In the Drawings:

Enclosed please find three (3) pages of proposed drawing corrections for Figures 1-3, 5, and 6. The proposed corrections are highlighted in red. A letter to the Official Draftsperson has also been provided with a copy of the proposed drawing corrections. The Examiner's approval is respectfully requested for the proposed changes to the drawings shown in red ink. The following corrections are made to Figures 1-3, 5, and 6.

Fig. 1

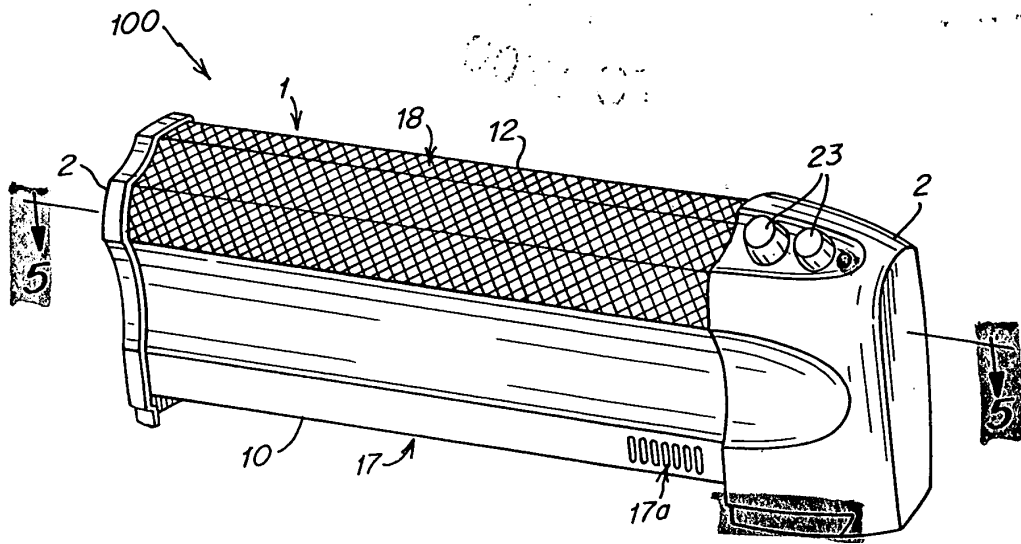
Callout for sectional view A-A has been changed to sectional view 5-5.

An indicator light has been added near the user interface 23 to be consistent with originally filed Figure 4.

An ornamental cutout has been added at the lower front facing edge of the left hand end cap, shown at the right hand side of the picture to be consistent with originally filed Figure 4.

Fig. 2

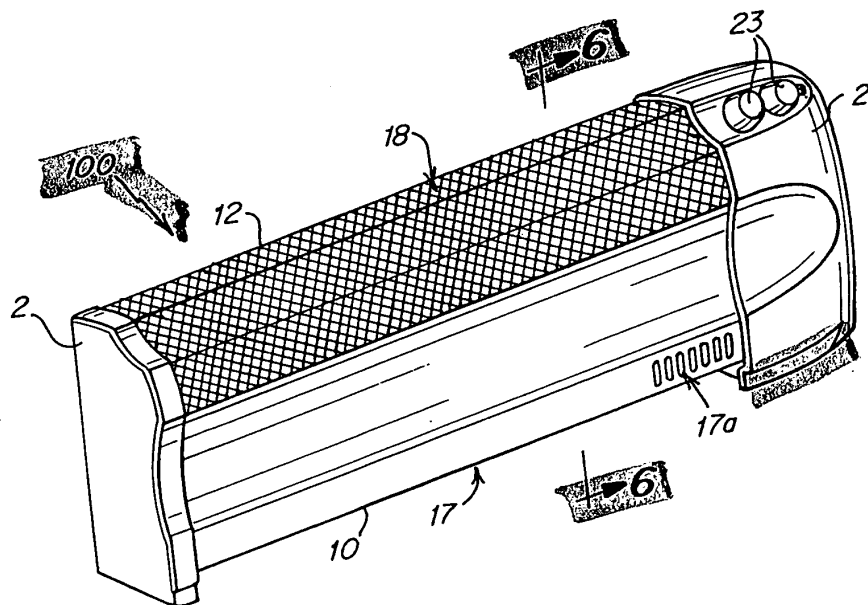
Callout for sectional view B-B has been changed to sectional view 6-6.

A callout for a heater, item 100 has been added.

An indicator light has been added near the user interface 23 to be consistent with originally filed Figure 4.

An ornamental cutout has been added out the lower front facing edge of the left hand end cap, shown at the right hand side of the picture to be consistent with originally filed Figure 4.

Fig. 3

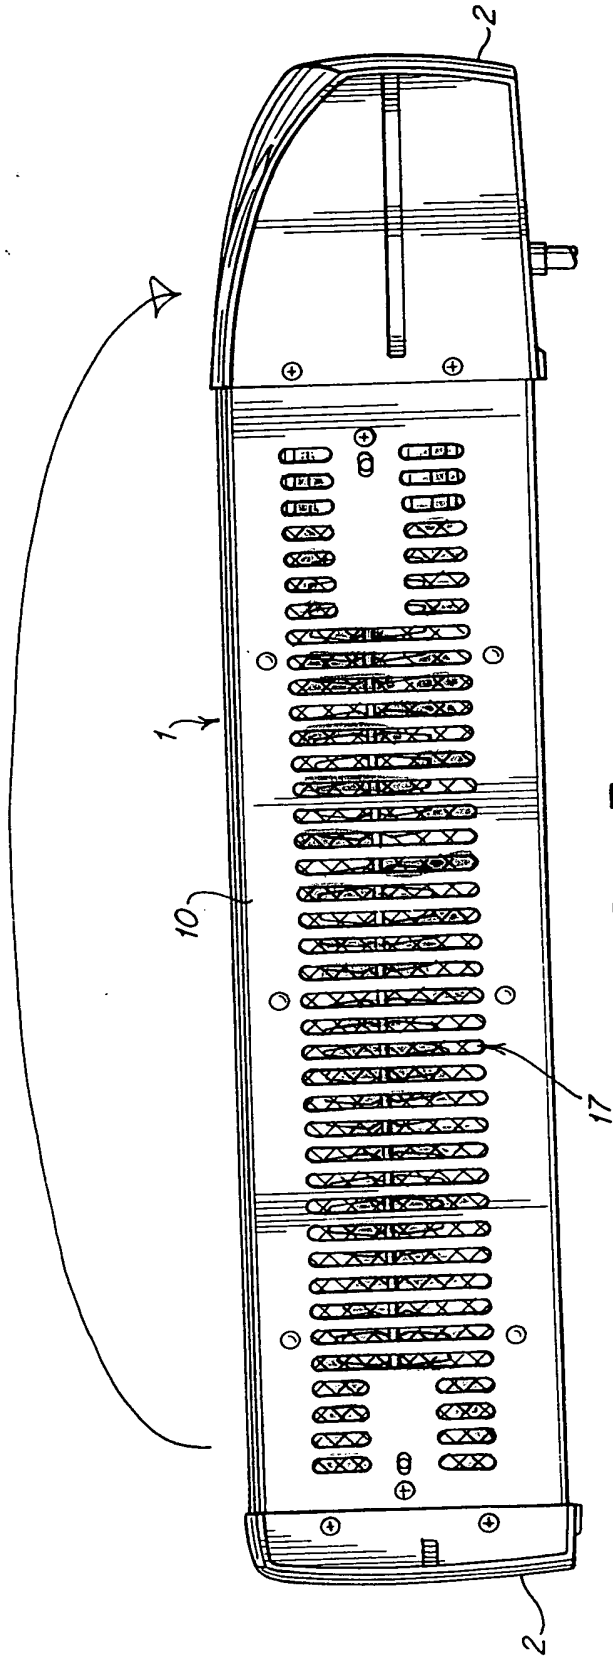
The entire view has been rotated 180°.

The grill is now shown through the air inlet 17.
